CITY OF KELOWNA

MEMORANDUM

Date: January 15, 2021
File No.: Z21-0062
To: Community Planning (AF)
From: Development Engineering Manager (RO)
Subject: 1310 St Paul St

I2 to C7rcs

CLIENT:	VIBONA ENTERPRISES LTD.		
PROJECT:	BUILDING RENOVATION		
TITLE:	SITE PLAN		
DWG NO:	A100	REV:	0
DRAWING SIZE:	A1	DRWN:	MS
SCALE:	1 : 100	DSGN:

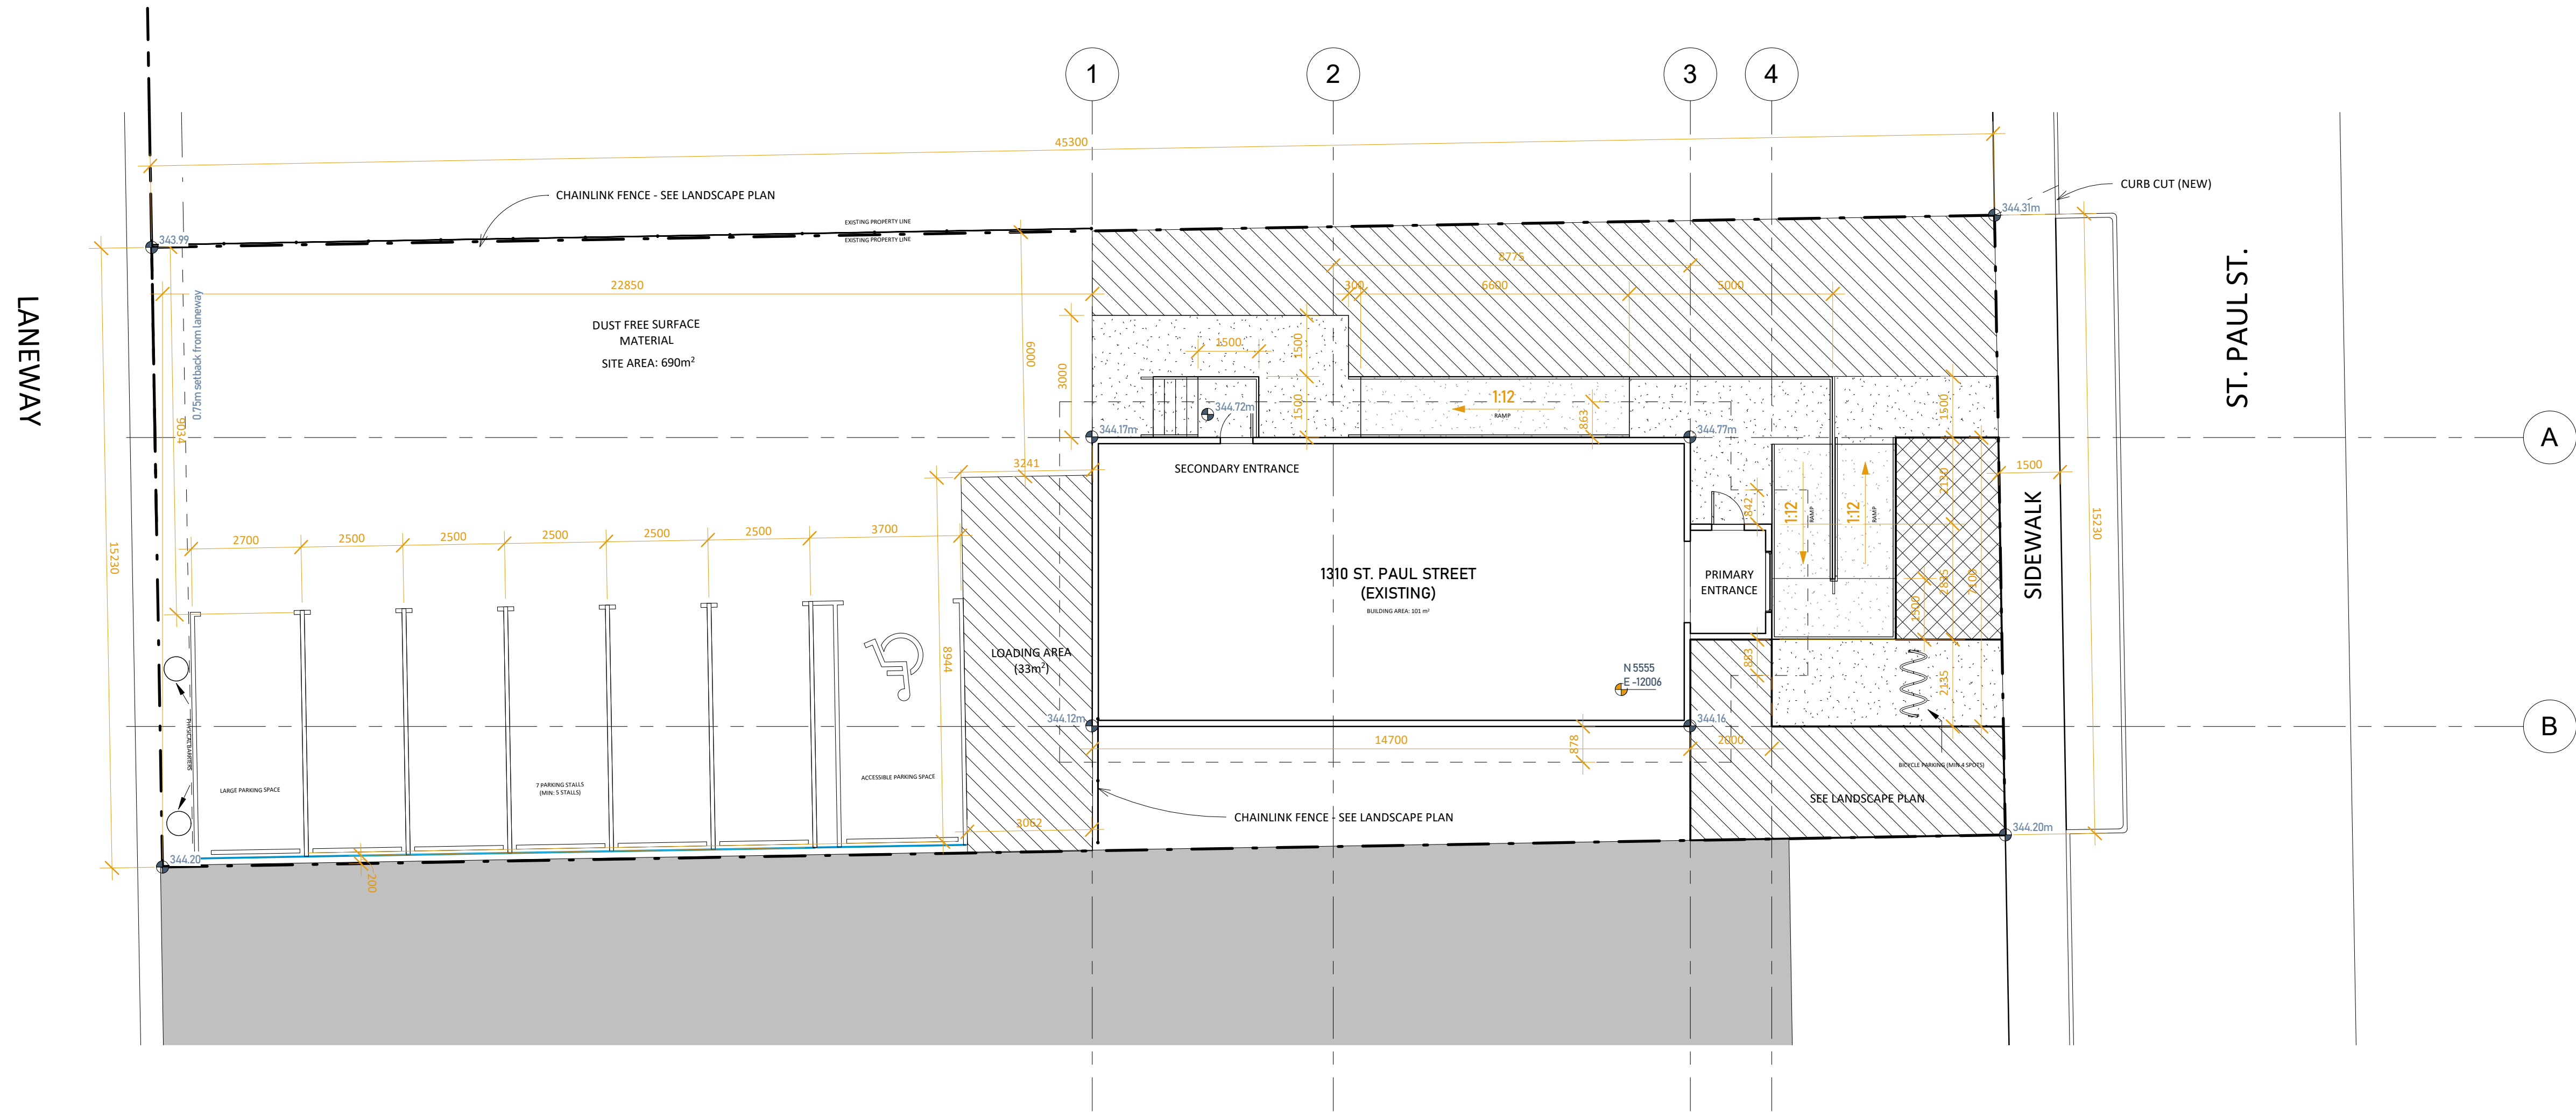
- a. St Paul Street must be upgraded to an urban standard (modified SS-R5) along the full frontage of this proposed development, including barrier curb and gutter, removal and replacement of deteriorated sidewalk, LED streetlighting, drainage system including catch basins, pavement removal and replacement, fillet paving, landscaped and irrigated boulevard, and re-location or adjustment of utility appurtenances if required to accommodate the upgrading construction.

- b. The applicant will be required to tie into the existing curb and gutter to the north of the subject lot.
- c. The Lane fronting the property requires asphalt widening to upgrade to a SS-R2 Commercial Lane standard along the full frontage of this proposed development.

- a. A road dedication of approximately 0.75 m is required along the entire property line fronting the lane to achieve a 7.6m ROW as per SS-R2 Commercial Lane standard detail.
- b. All access to the development must be from the lane, no access from St. Paul St will be permitted.
